Project	<b>IEEE 802.16 Broadband Wireless Access Working Group</b> < <a href="http://ieee802.org/16">http://ieee802.org/16</a> >
Title	<b>Amendment to RSA Security Primitives in 14.2.2.2</b>
Date Submitted	<b>2007-03-0814</b>
Source(s)	Jung-Mo Moon, Jeehyeon Na, Mi-Young Yun, and Sangho Lee <a href="mailto:jhna@etri.re.kr">jhna@etri.re.kr</a> ETRI 161 Gajeong-dong, Yuseong-gu Daejeon 305-700 Korea
Re:	Contribution on comments to IEEE 802.16g/D8
Abstract	Re-definition of RSA primitives in section 14.2.2.2
Purpose	Adoption
Notice	This document has been prepared to assist IEEE 802.16. It is offered as a basis for discussion and is not binding on the contributing individual(s) or organization(s). The material in this document is subject to change in form and content after further study. The contributor(s) reserve(s) the right to add, amend or withdraw material contained herein.
Release	The contributor grants a free, irrevocable license to the IEEE to incorporate text contained in this contribution, and any modifications thereof, in the creation of an IEEE Standards publication; to copyright in the IEEE's name any IEEE Standards publication even though it may include portions of this co

Figure 474 – RSA based Authentication Procedure

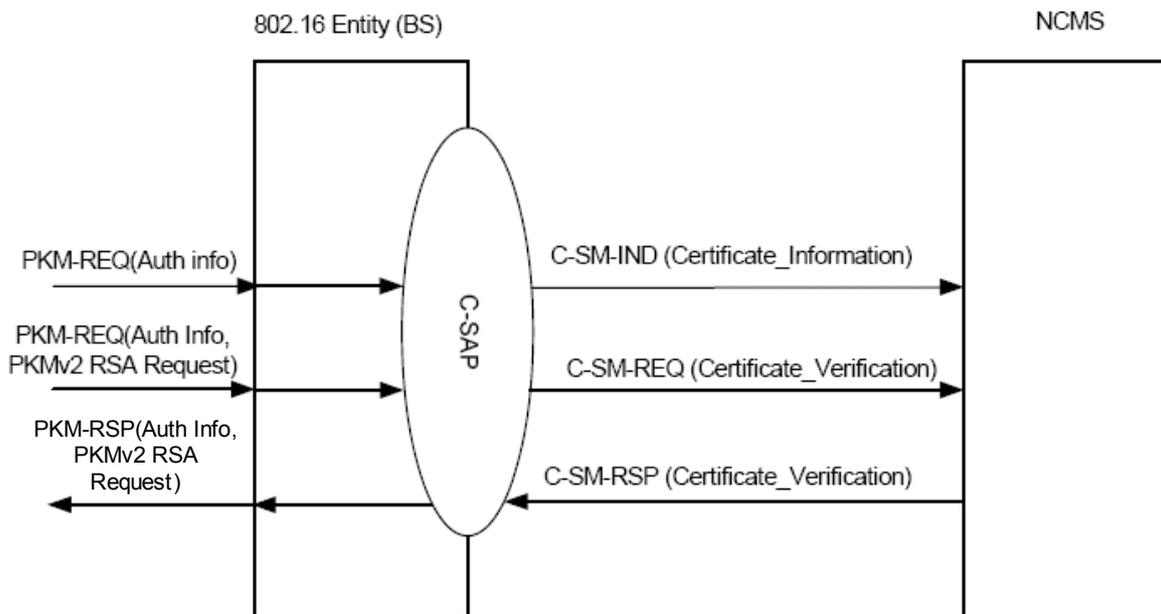
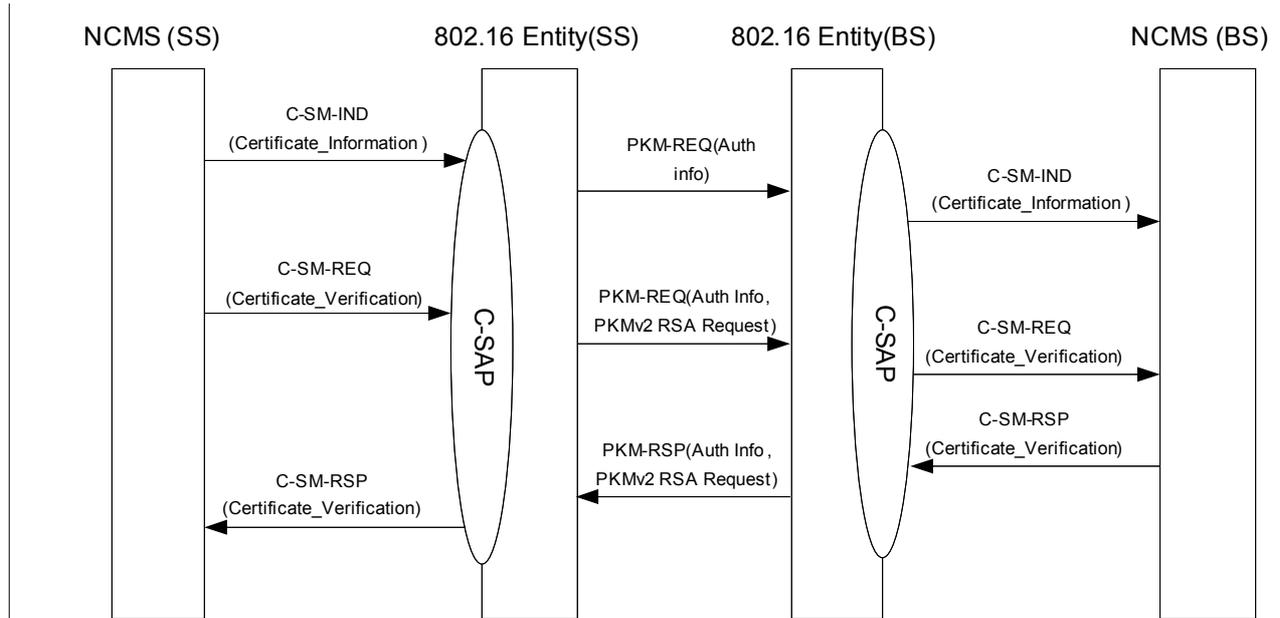
1. Modification of figure 474 which illustrate security primitives on the SS side.
2. Modification of each subsection to clarify and describes on each side (SS and BS side)

Figure 474 shows a RSA-based authentication procedure between an 802.16 entity a BS and ~~the~~ an NCMS on the MS side and the BS side entity as follows:
